### Amendment C245 Queen Victoria Market Precinct Renewal

26 July 2016

**Panel Report**

# Melbourne Planning Scheme Amendment C245 Queen Victoria Market built form controls

Figure 6 Exhibited QVM Precinct Framework Plan – Table 1 of DPO11

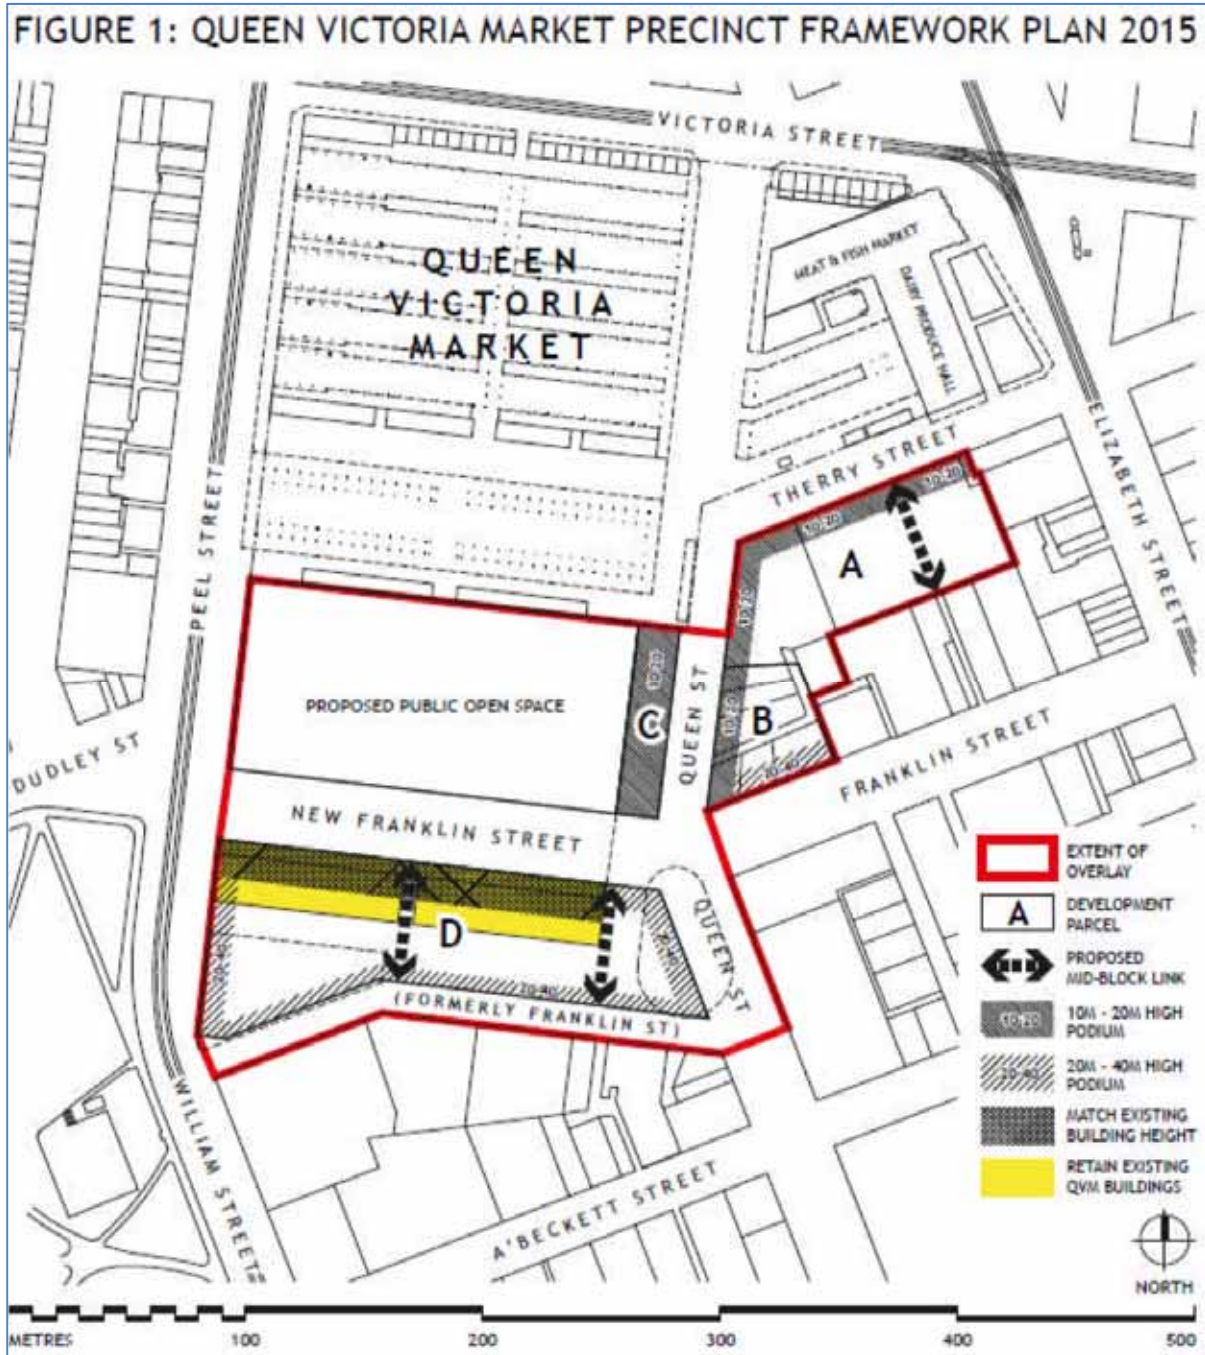
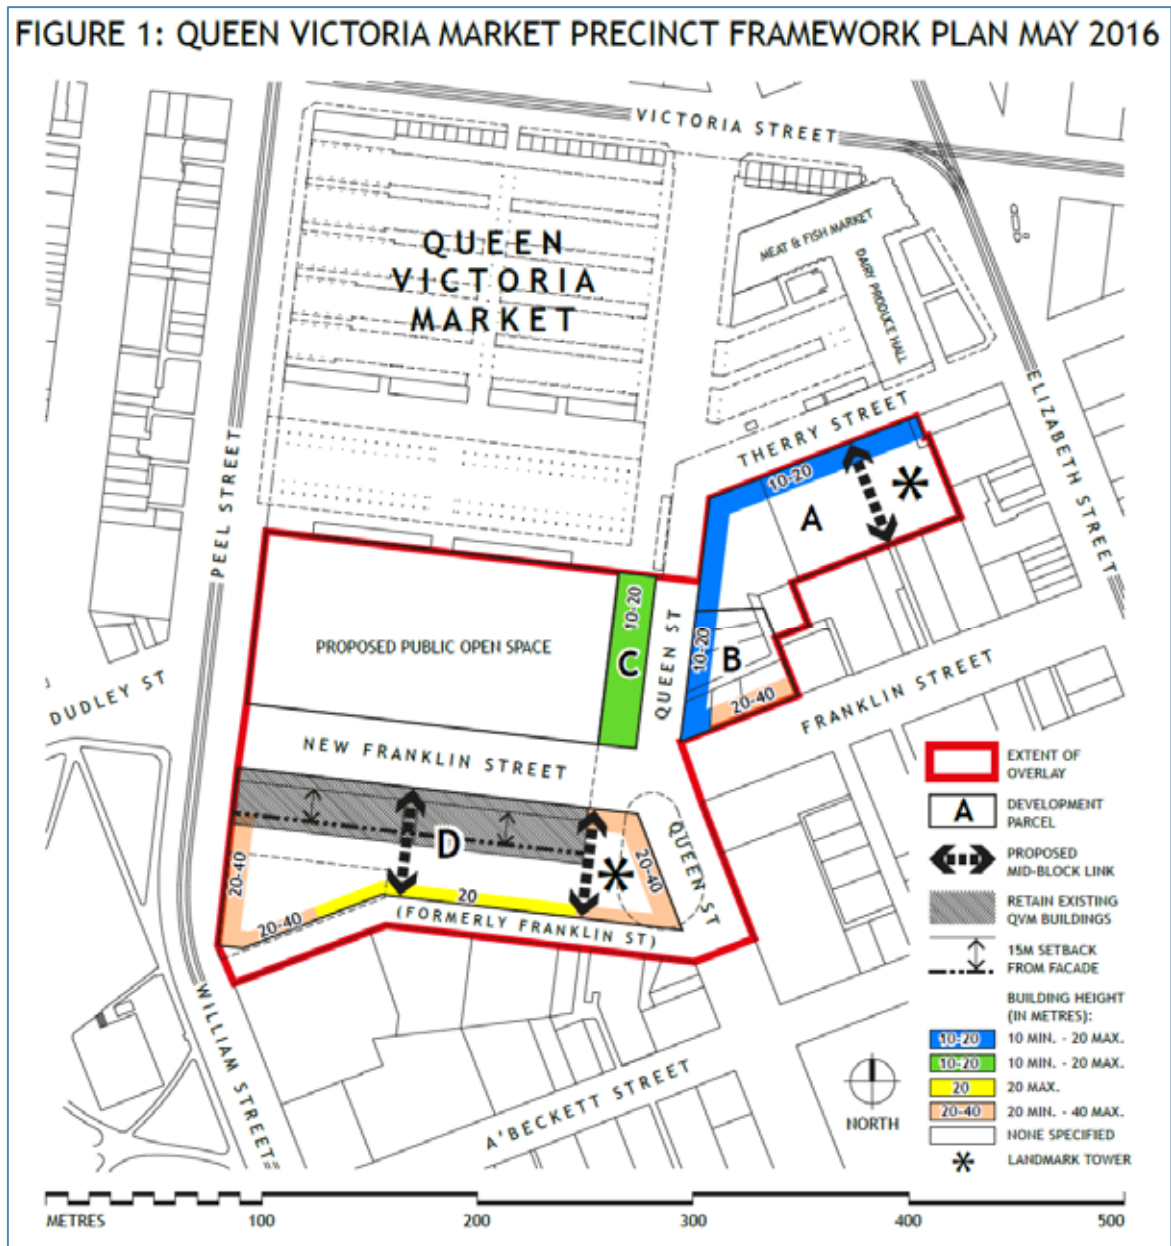
Any proposal to exceed the height limits would need to be supported by 3D modelling and assessment of the visual impact when viewed from the proposed open space. The Panel also sees merit in using the Framework Plan in Figure 1 of DPO11 to nominate the locations where the highest built form should be directed, as was proposed during the course of the Hearing, and is shown in the amended Framework Plan (Figure 10).

- 1. Amend the Framework Plan at Figure 1 of the Development Plan Overlay Schedule 11 as follows:**
  - a) Include a discretionary overall height limit of 100 metres for Parcel A and 40 metres for Parcel B.**

- b) Require a mandatory 10 metre tower setback from the front of podium to Therry Street and Queen Street, in Parcel A as shown in Figure 1.
- c) Provide for a discretionary 20 metre minimum podium height and require a mandatory 40 metre podium height for the property located at the north east corner of Queen Street and Franklin Street.

- d) Provide for a discretionary 10 metre tower setback from the front of podium to Queen Street for Parcel B, as shown in Figure 1. Alternatively, a mandatory 5 metre front setback could also be specified.

- e) Require a mandatory 5 metre tower setback from the front of podium to Franklin Street for Parcel B, as shown in Figure 1.
- f) Require a mandatory 5 metre side and rear tower setback from boundaries or the centre of a laneway, rather than the 10 metres as proposed.

During the course of the Hearing, Council submitted alternative DPO11 Figure 1 QVM Framework Plan in response to matters raised in evidence, including nominated locations for marker buildings (but no overall height or plot ratios) for Parcels A and D, adjusted podium heights and setbacks for Parcel D, and clarity around podium heights at the corner of Queen and Franklin Streets. This is shown in Figure 10.

PANEL RECOMMENDATION	ACCEPT/REJECT	MANAGEMENT RESPONSE
<b>Development Plan Overlay Schedule 11 (DPO11)</b>			
1.	<p>Amend the Framework Plan at Figure 1 of the Development Plan Overlay Schedule 11 as follows:</p> <ul style="list-style-type: none"> <li>a) Include a discretionary overall height limit of 100 metres for Parcel A and 40 metres for Parcel B.</li> <li>b) Show podium height of 20 metre minimum to 40 metre maximum on the property located at the north east corner of Queen Street and Franklin Street.</li> <li>c) Show the location for greatest height being towards the Elizabeth Street end of the Parcel A, to the east of the proposed through block link.</li> </ul>	Accept	<p><i>Discussion:</i></p> <p>Provisions have been included to specify preferred heights in DPO11.</p> <p>Provisions have also been included to increase the development capacity of Parcel B which is slightly more removed from the Market than Parcel A, the Council owned land.</p> <p><i>Recommendation:</i></p> <p>The Framework Plan at Figure 1 of the DPO11 has been amended to reflect the recommendations of the Panel.</p>

The Framework Plan at Figure 1 of the DPO11 has been amended to reflect the recommendations of the Panel.
6.	<p>Amend 'Conditions and requirements for permits' in Development Plan Overlay Schedule 11 as follows:</p> <ul style="list-style-type: none"> <li>a) Require podiums fronting New Franklin Street where they abut the heritage listed Stores Buildings to have a mandatory maximum podium height of 20 metres.</li> <li>b) Remove the reference to a cantilever built form over the rear of the heritage listed Stores Buildings</li> <li>c) Require Podiums fronting Little Franklin Street between William Street and Queen Street should have a mandatory maximum podium height of 20 metres, except at the block ends as shown in the framework plan where podiums should have a discretionary minimum podium height of 20 metres and must have a mandatory maximum podium height of 40 metres.</li> <li>d) Require mandatory tower setbacks for towers facing new Franklin Street to be a mandatory minimum of at least 15 metres behind the northern masonry facades of the existing sheds.</li> <li>e) Require a mandatory 10m tower separation distance to apply to 'towers within a site', or from 'existing or approved towers on adjoining sites'.</li> <li>f) Nominate a discretionary overall height limit of 100 metres for Parcel D and with the location for greatest height being towards the Queen Street end of the Parcel D. Any application to exceed this height should be supported by 3D modelling and an assessment of the visual impact on the open space and public realm</li> </ul>	Accept	<p><i>Discussion:</i></p> <p>Revised provisions have been included to ensure new development responds sympathetically to the Stores building which is part of the Heritage Registered area. This includes a discretionary overall height limit of 100 metres for parcel D.</p> <p>Because New Franklin Street is narrow reduced podium heights (except at block ends) allow more light to the street.</p> <p><i>Recommendation:</i></p> <p>The Conditions and Requirements for permits in the DPO11 have been amended to reflect the recommendations of the Panel.</p>

Figure 13 Extent of DDO14 recommended by Ms Heggen  
Source Ms Heggen's Evidence Figure 21

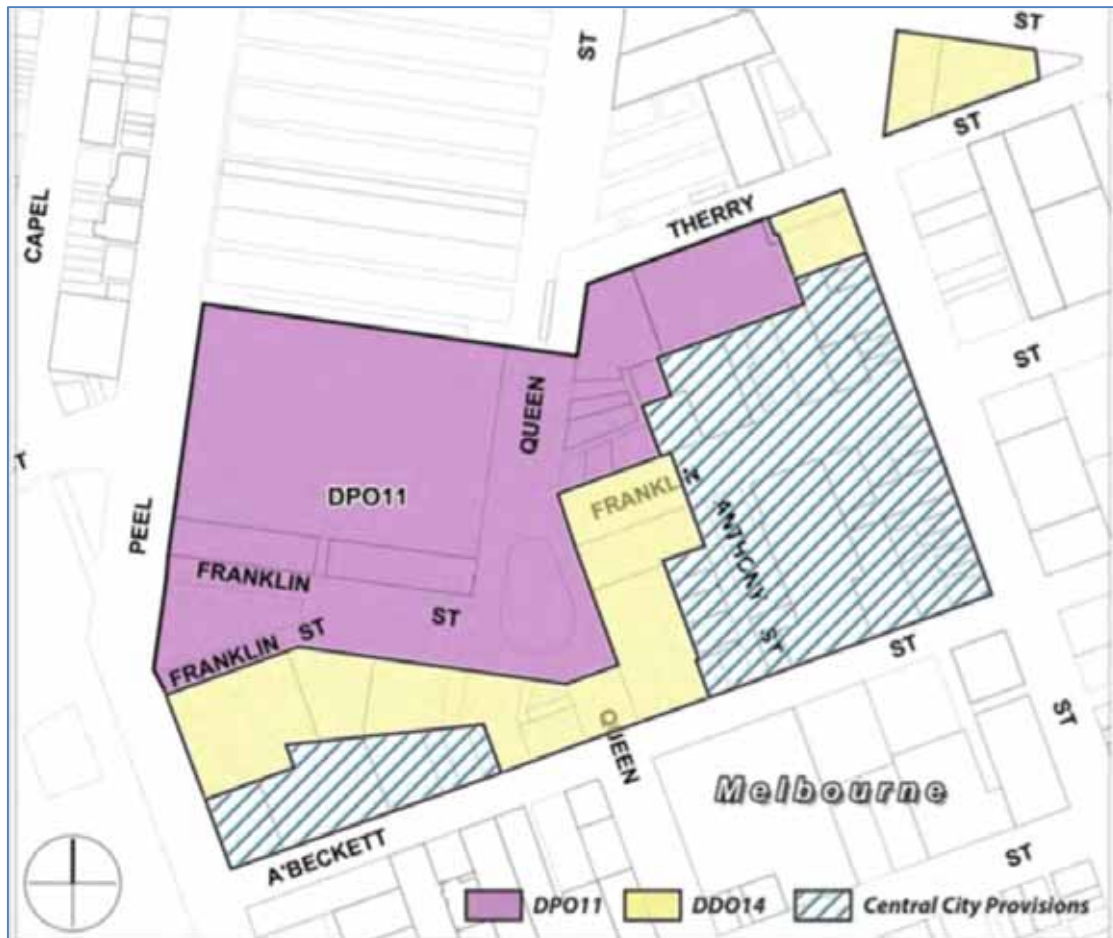
Ms Heggen gave evidence that an option would be to contract the mapped extent of DDO14 area to apply to the 'market environs' area with recommended changes and consolidate the balance of the area into DDO10 and apply DDO10 provisions. See Figure 13.

In verbal evidence and cross examination Ms Heggen articulated that she considered the DDO14 area still had some "heavy lifting" to do in terms of managing the *current* interface with the market. Ms Heggen explained that this was more of a temporal issue conditional upon the resolution of C270 and completion of new development parcels within the DPO area, at which point she considered the DDO14 controls should be reviewed.

Figure 14 DPO11 boundary, showing 501-503 Elizabeth Street, highlighted in red

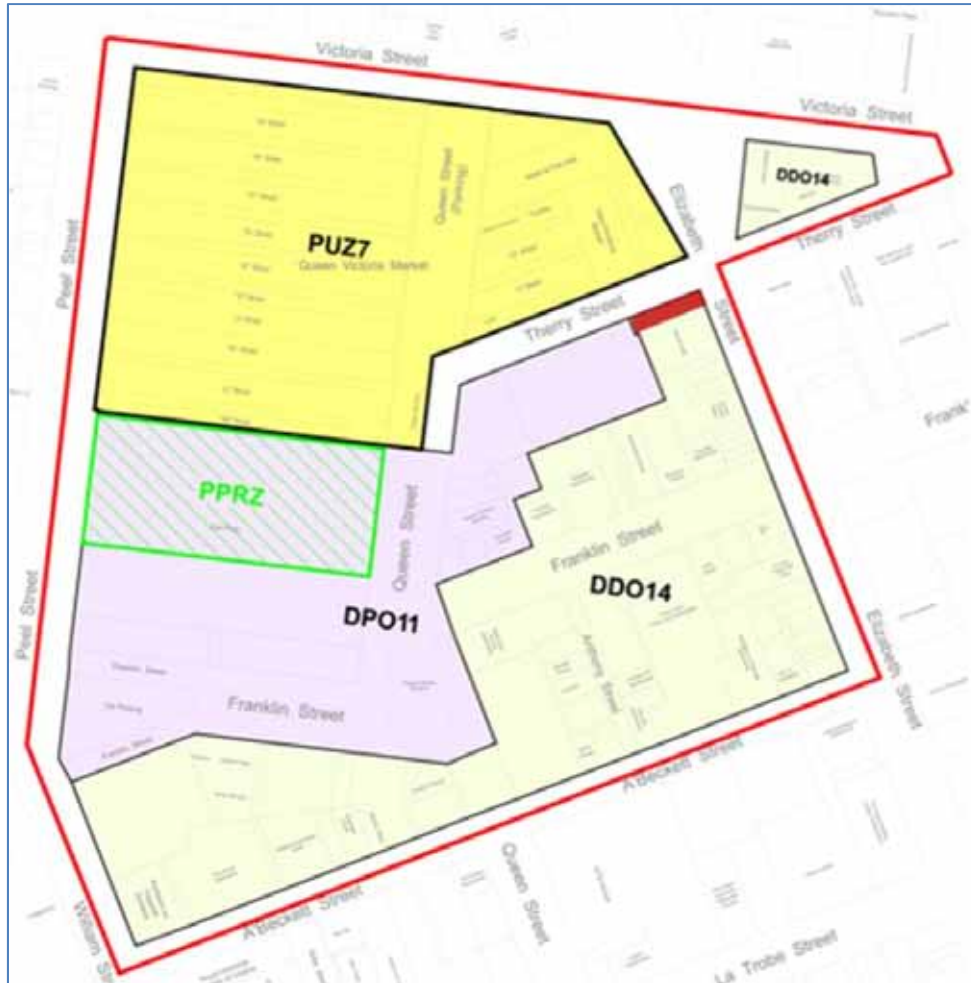
*these properties is recommended ... I consider Council has been remiss in not recognising this special component of the precinct.*<sup>56</sup>

During the course of the Hearing, a question was raised about whether the DPO boundary should also be modified to include the additional HO7 property facing Franklin Street. The Panel notes that Mr Lovell's evidence stated *"this section of Franklin Street ... has no heritage sensitivity as related to the QVM and with the south side of the street, increasingly presents as part of the central city core"*<sup>57</sup>.
